DRAINAGE CONFORMANCE LETTER
FOR
WALDEN SANITATION DISTRICT WWTP
3155 WALKER ROAD, EL PASO COUNTY, COLORADO
PART OF WALDEN PRESERVE 2 – FILING NO. 5

NOVEMBER 2025
REVISED MARCH 2026

PCD FILE PPR2538

V3_ FDR.pdf Markup Summary

PROJECT: WALDEN CORPORATION WWTP 3155 WALKER ROAD COLORADO SPRINGS EL PASO COUNTY, COLORADO	SHEET TITLE: SITE DEVELOPMENT PLAN	
ENGINEER: AQUAWORKS DBO, INC. 3252 WILLIAMS STREET DENVER, COLORADO 80205 (303) 477-5915	PROJECT NUMBER: PCD FILE PPR2538	SCALE: 1"=100'
		SHEET: C1.1

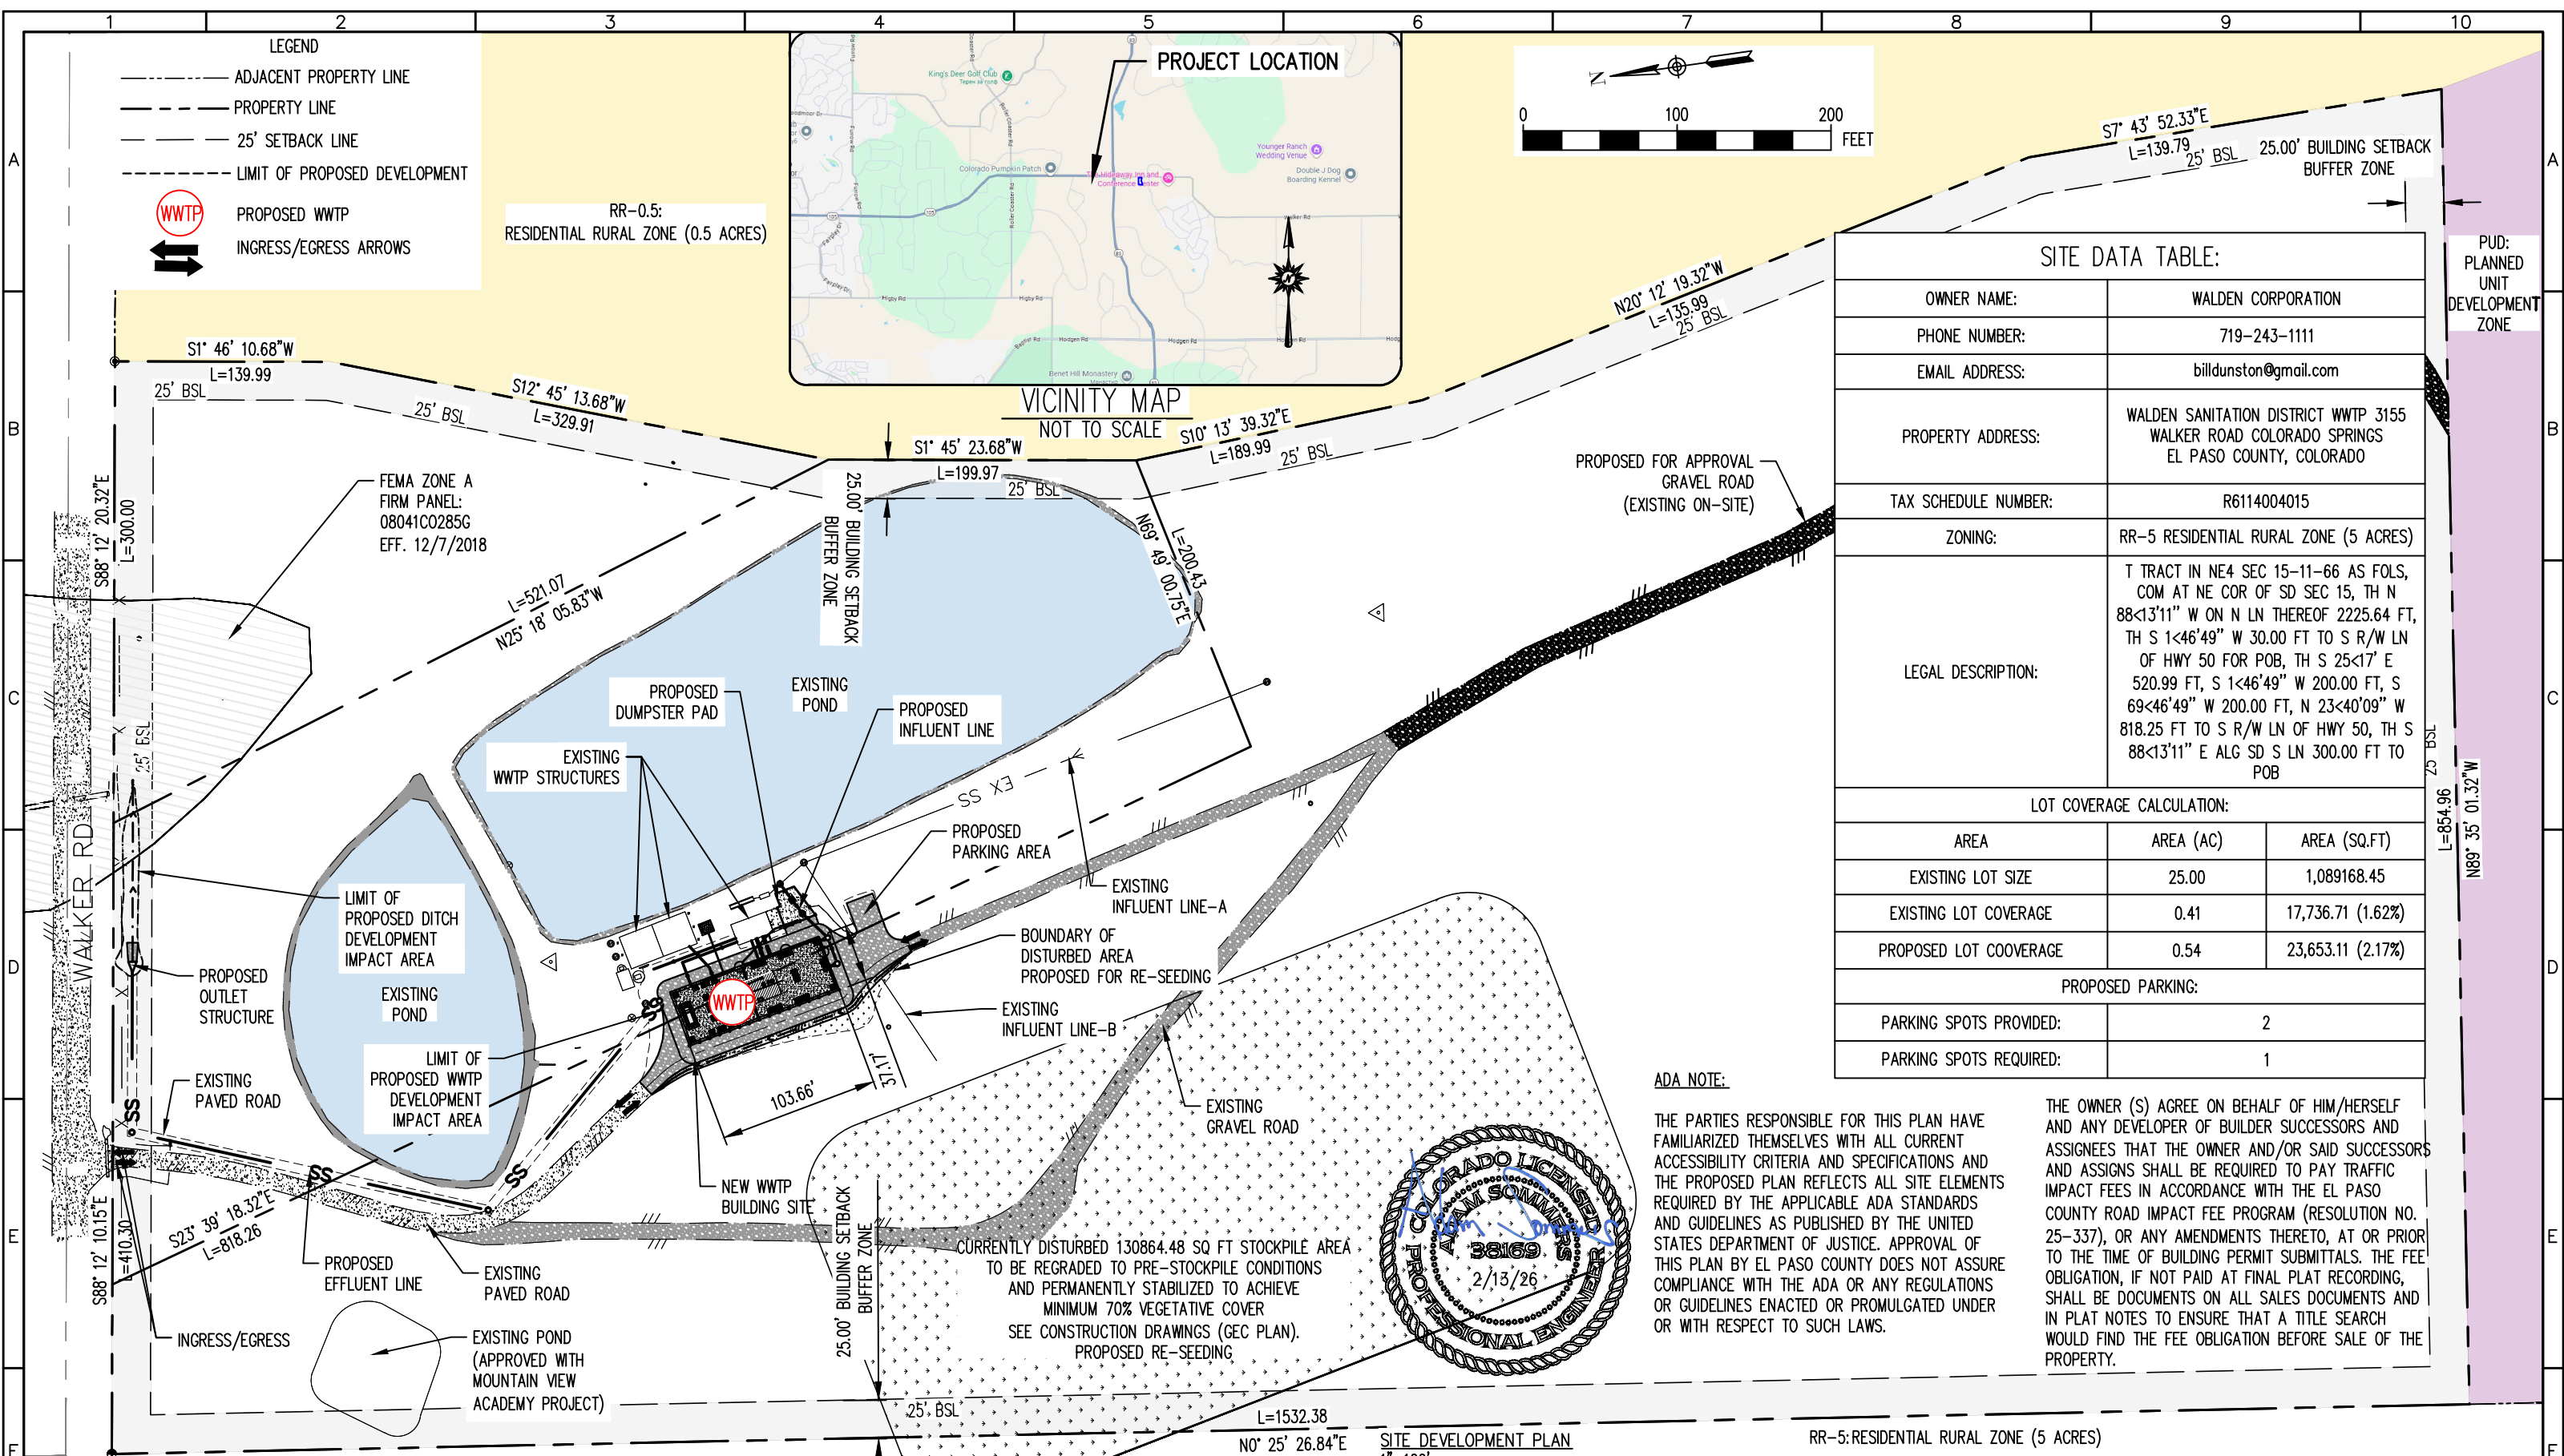
Site development plan shows pipes that will carry the flows from the pond basins to the north.

SHEET TITLE:
SITE DEVELOPMENT PLAN

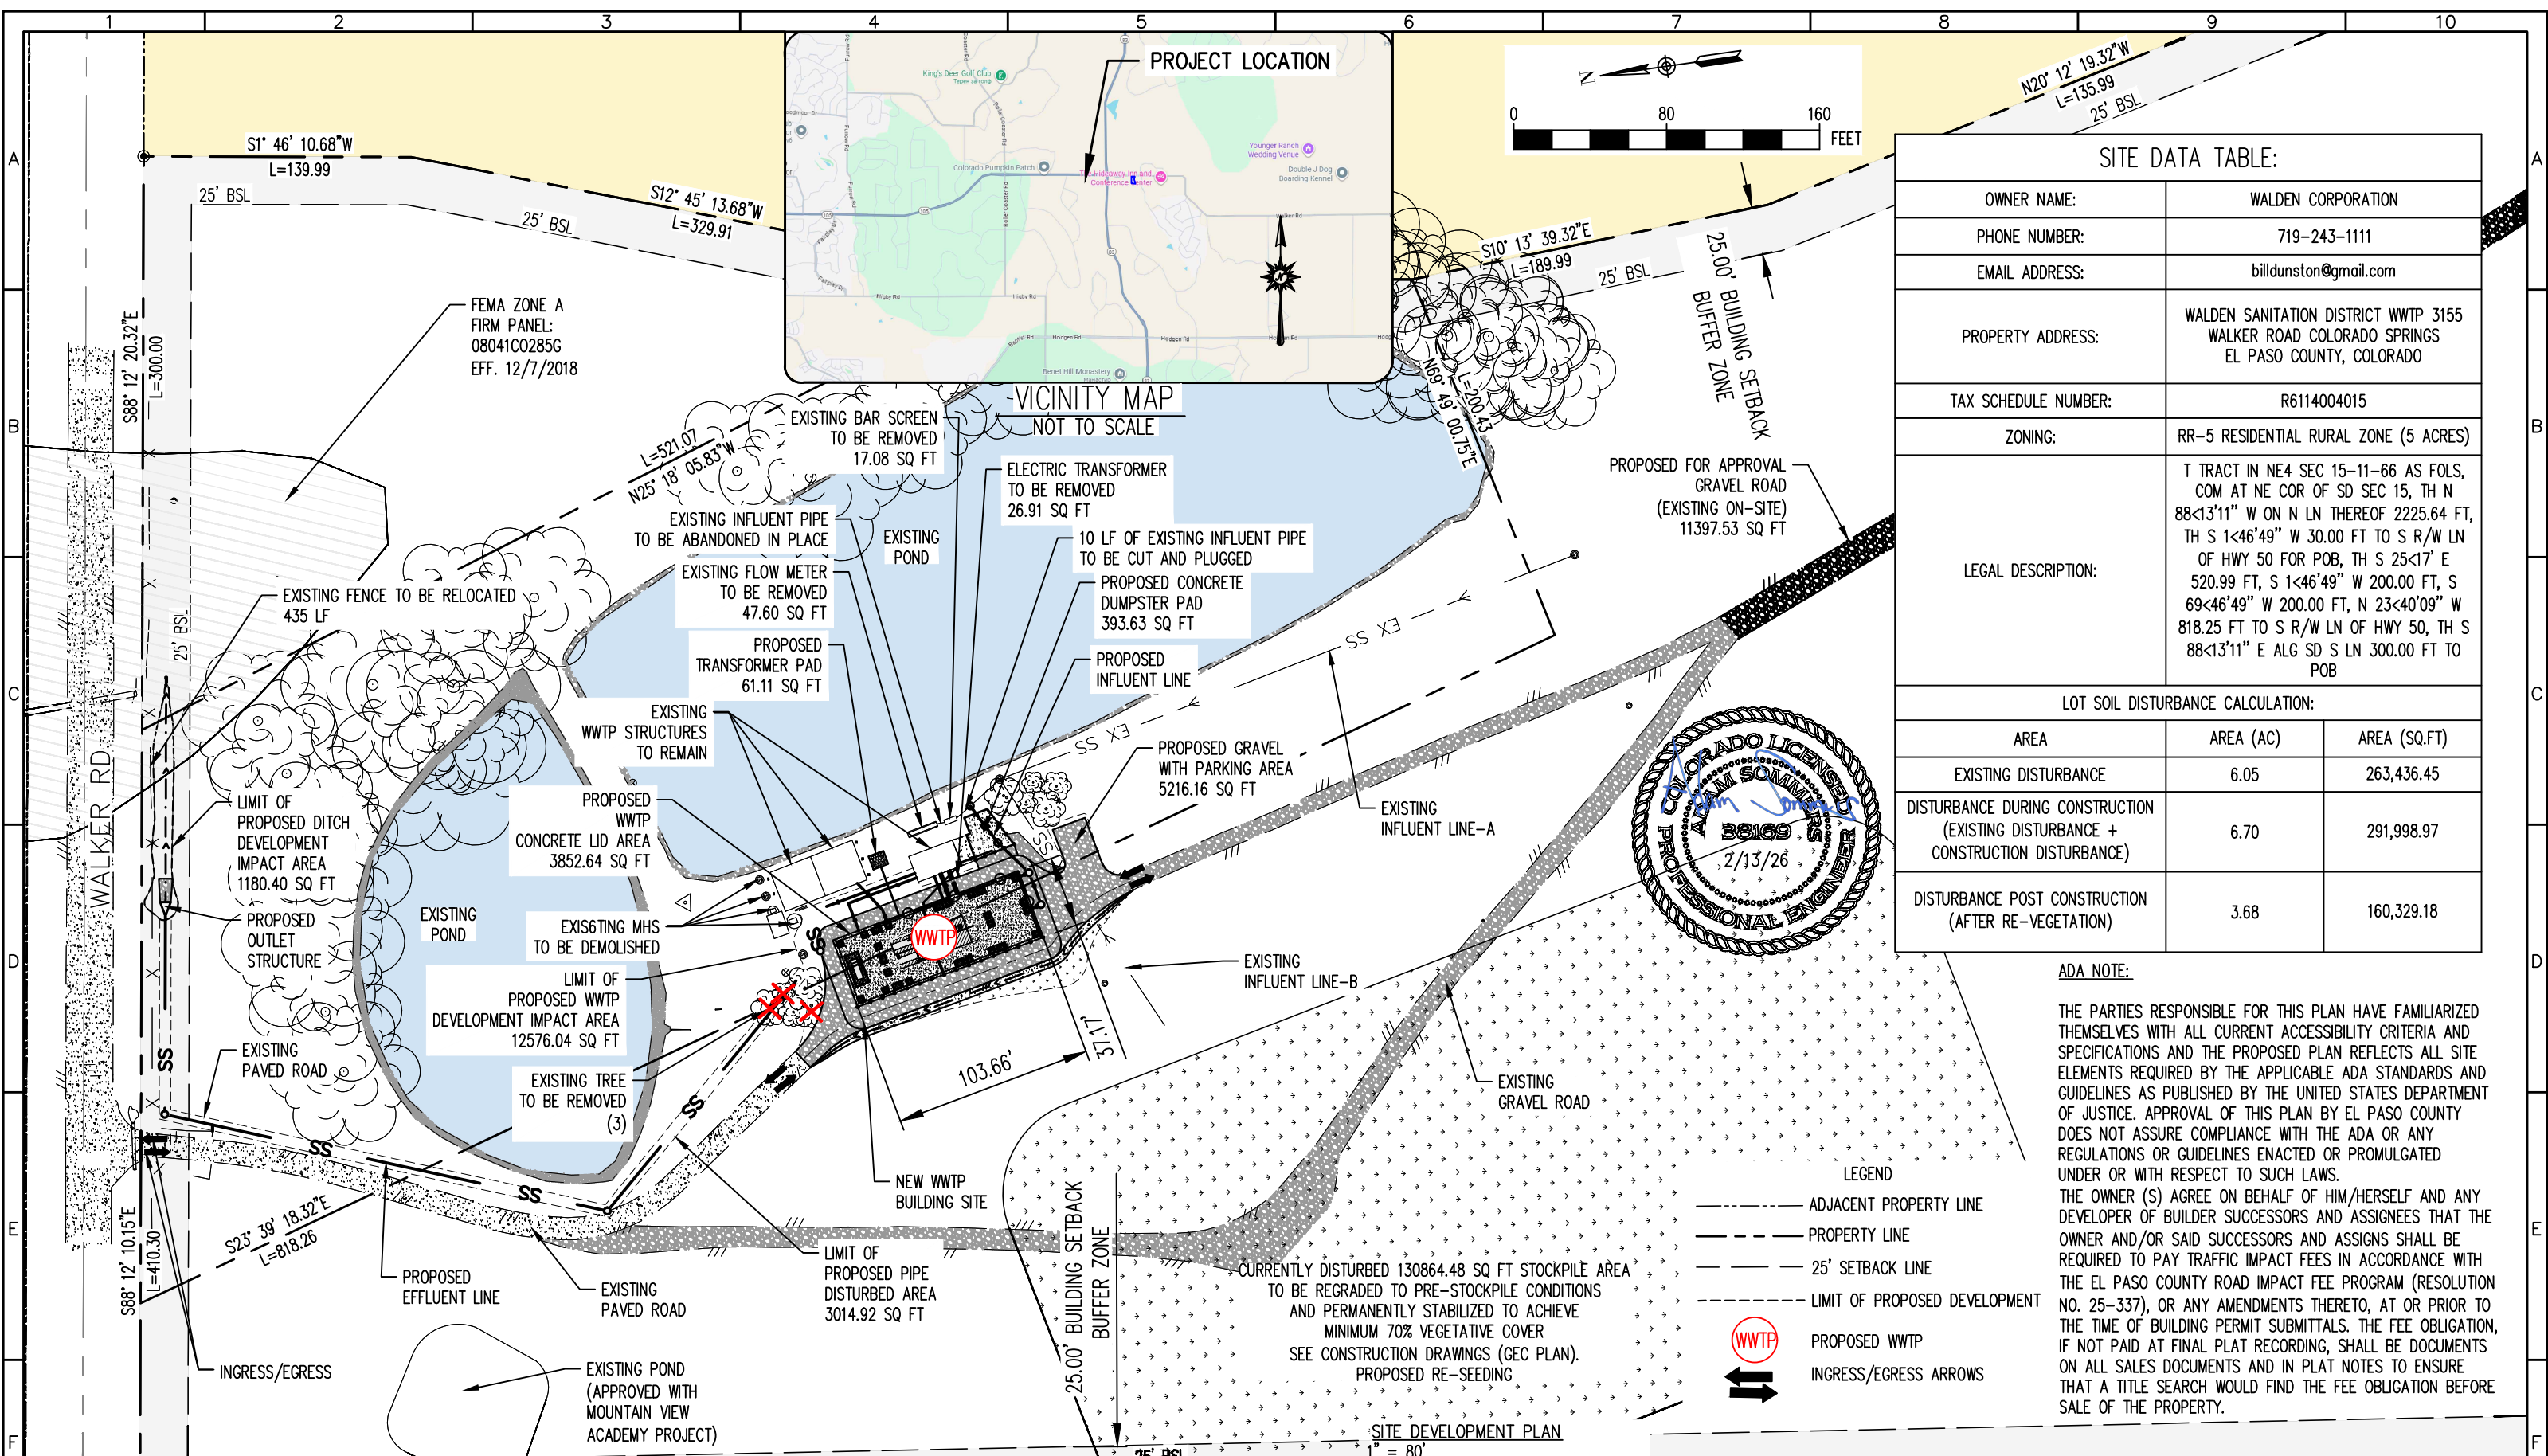
Site development plan shows drain pipes taking flows from these basins north. please revise.

Site development plan shows drain pipes taking flows from these basins north. please revise.
